MEETING SUMMARY
BRUNSWICK HYDROELECTRIC PROJECT

FERC NO. 2284

DOWNSTREAM FISH PASSAGE ALTERNATIVES MEETING

January 27, 2026

1. ELEVATIONS SHOWN IN THIS DRAWING SET ARE REFERENCED TO THE NORTH AMERICAN GEODETIC VERTICAL DATUM OF 1929 (NGVD29).

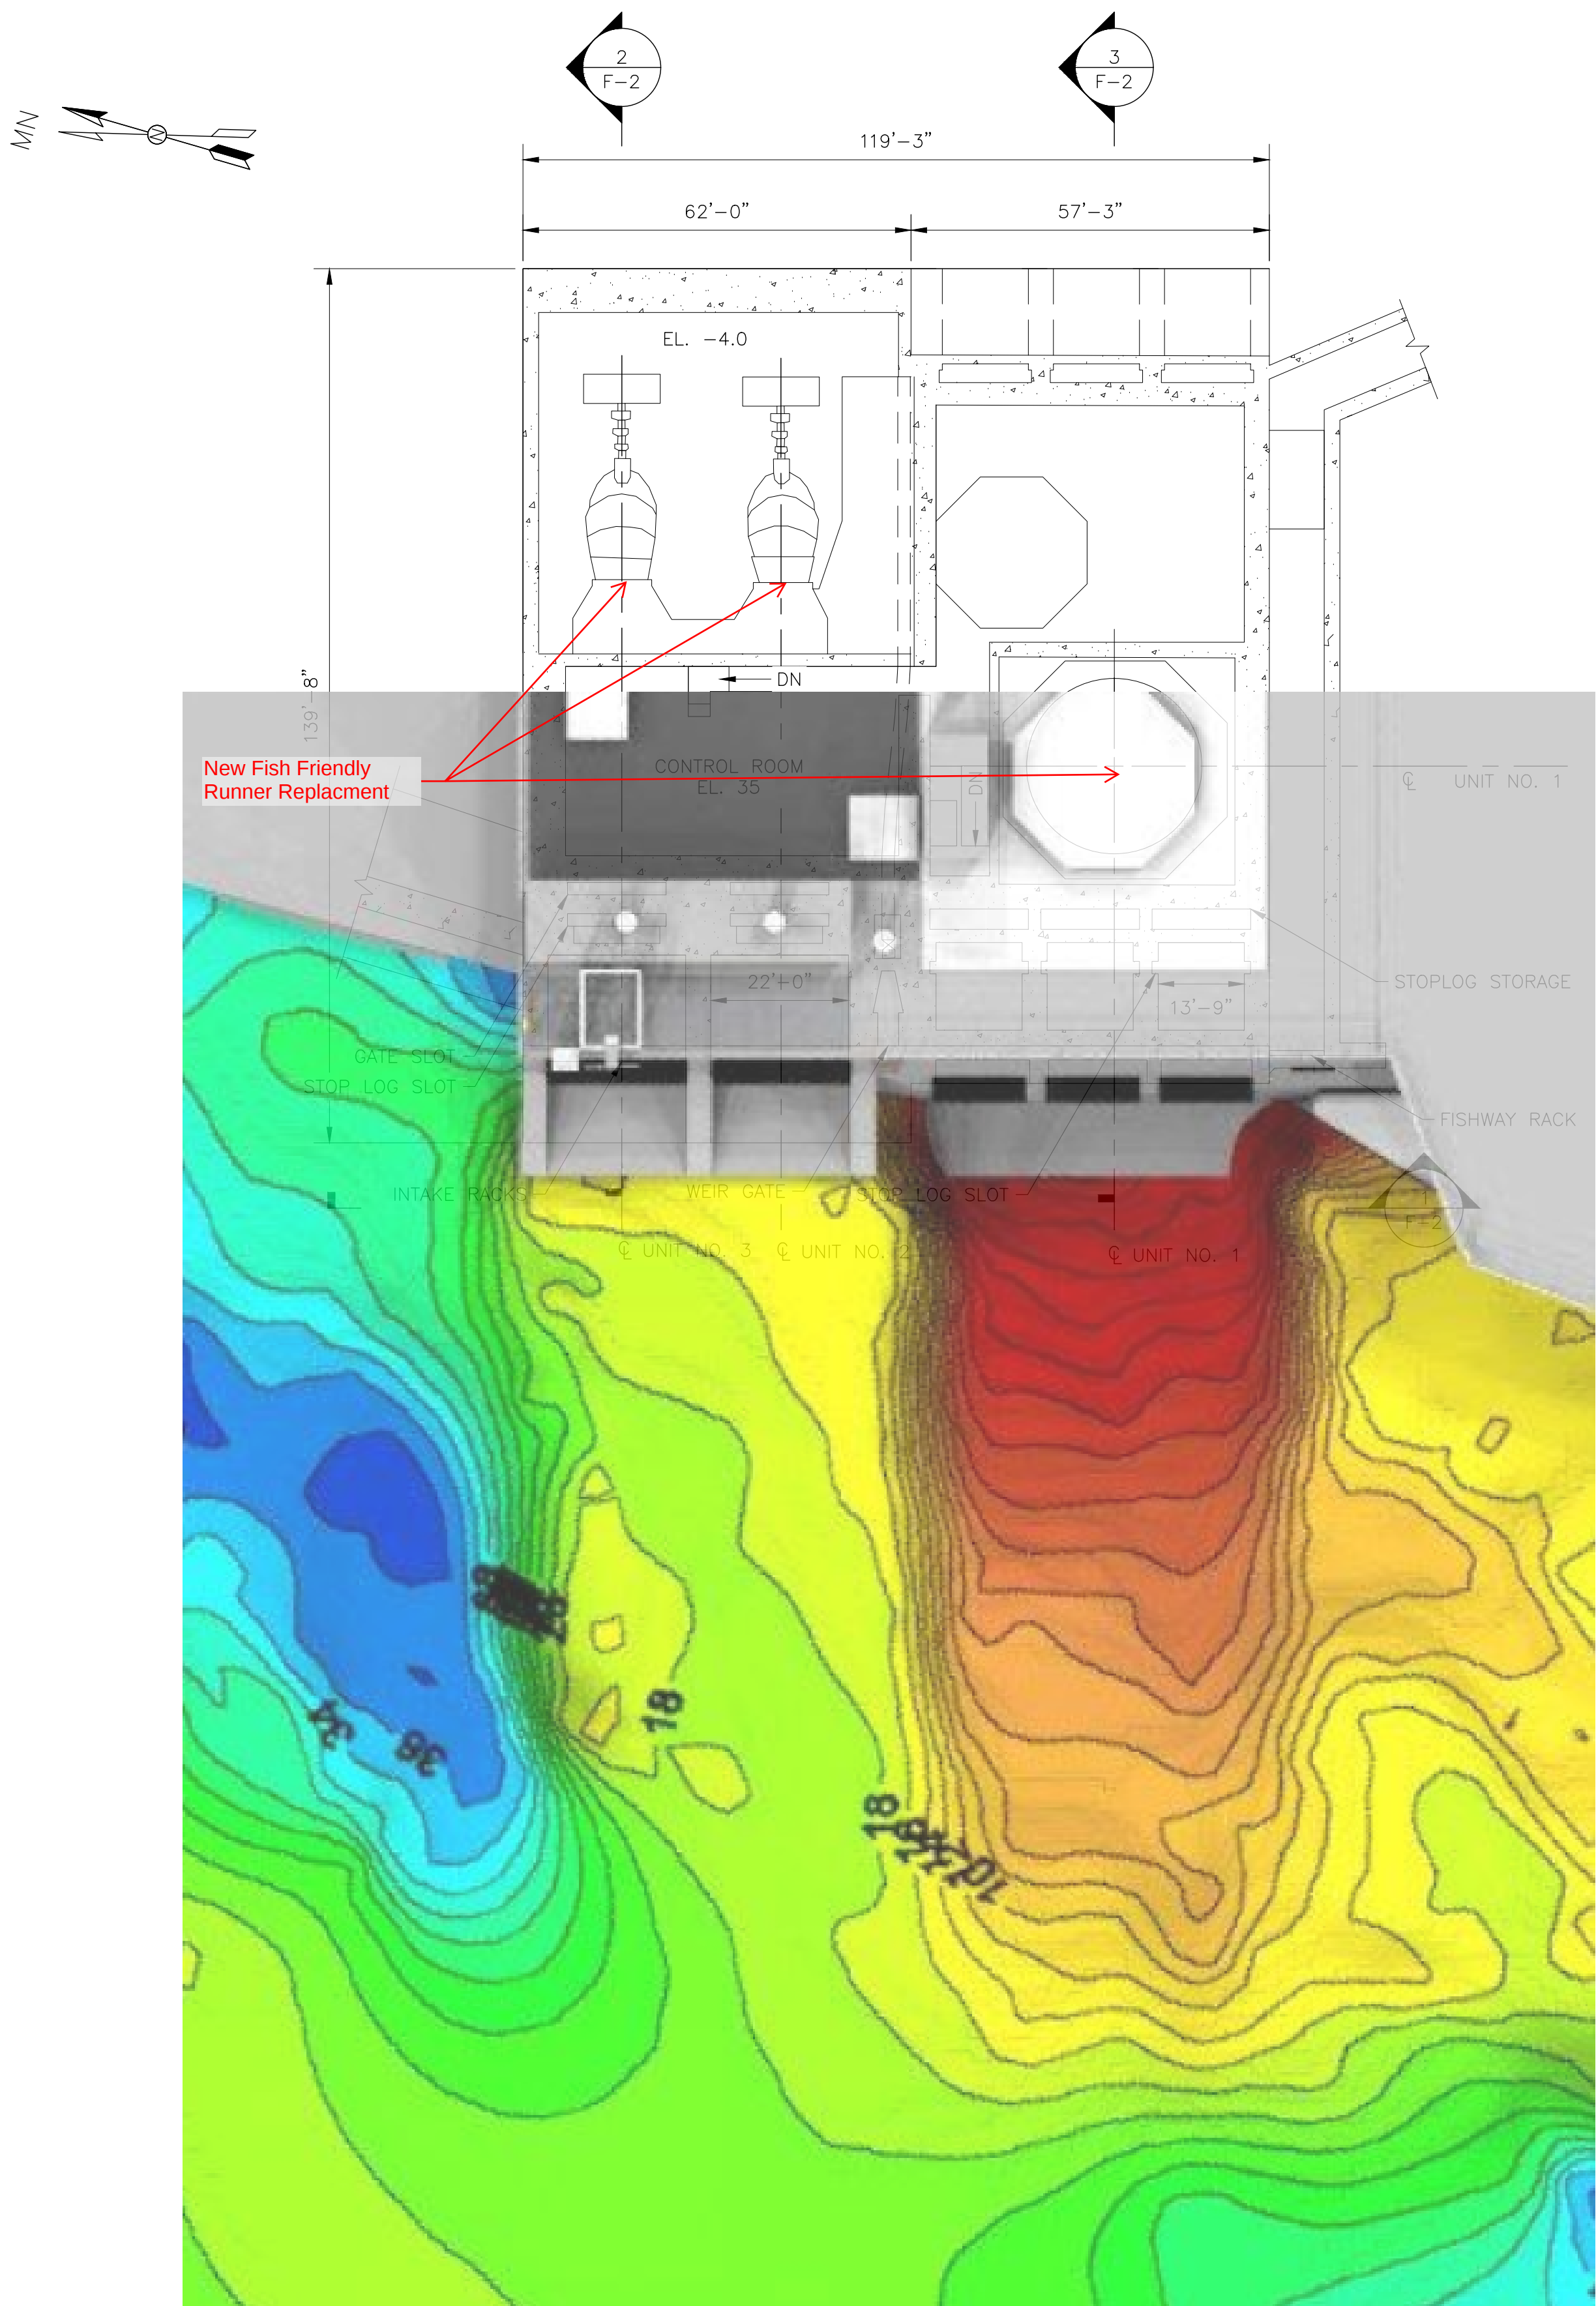
Casey Clark asked about the potential downstream bypass location and how that would be routed. Lucas replied that this alternative considered a bypass structure located just north of the powerhouse with a surface gate and then a low-level inlet. Lucas said it would be preferable to integrate the bypass into the rack face structure, but the layout of the intake did not lend itself to this type of solution. Casey Clark also asked about the infrastructure on river right (i.e., upstream fishway) and whether the river right training wall on the shore side of Unit 1 could be moved any further to the right to address potential velocity issues to prevent fish from being falsely attracted to the area. Lucas replied that the current layout tries to minimize impacts to upstream fishway, and a modification like moving a training wall could present design challenges if the upstream fish passage remains on river right.

Vladimir Douhovnikoff asked if it would make sense to examine the 1/2-inch rack spacing with this alternative. Lucas replied that the CFD modeling would not be able to assess changes in rack spacing from 3/4-inch to 1/2-inch. Vladimir Douhovnikoff stated that it may be helpful to know if closer spacing could be effective, and what the impact would be on generation. Kirk Smith stated that the selection of 3/4-inch clear spacing was being driven by the USFWS engineering guidelines, which reflects the protective spacing for American eel, and that examining closer spacing would begin to have significant impacts on generation likely making the alternative unfeasible relative to other options. Matt Buhyoff stated the results of the alternatives analysis will be filed with FERC, who will be developing their own license recommendations, and it would be premature to dismiss closer-spaced rack alternatives from the analysis, and their technical feasibility should be investigated. Mike Scarzello stated that Brookfield is following USFWS engineering guidelines with the 3/4-inch clear spacing described in the alternatives.
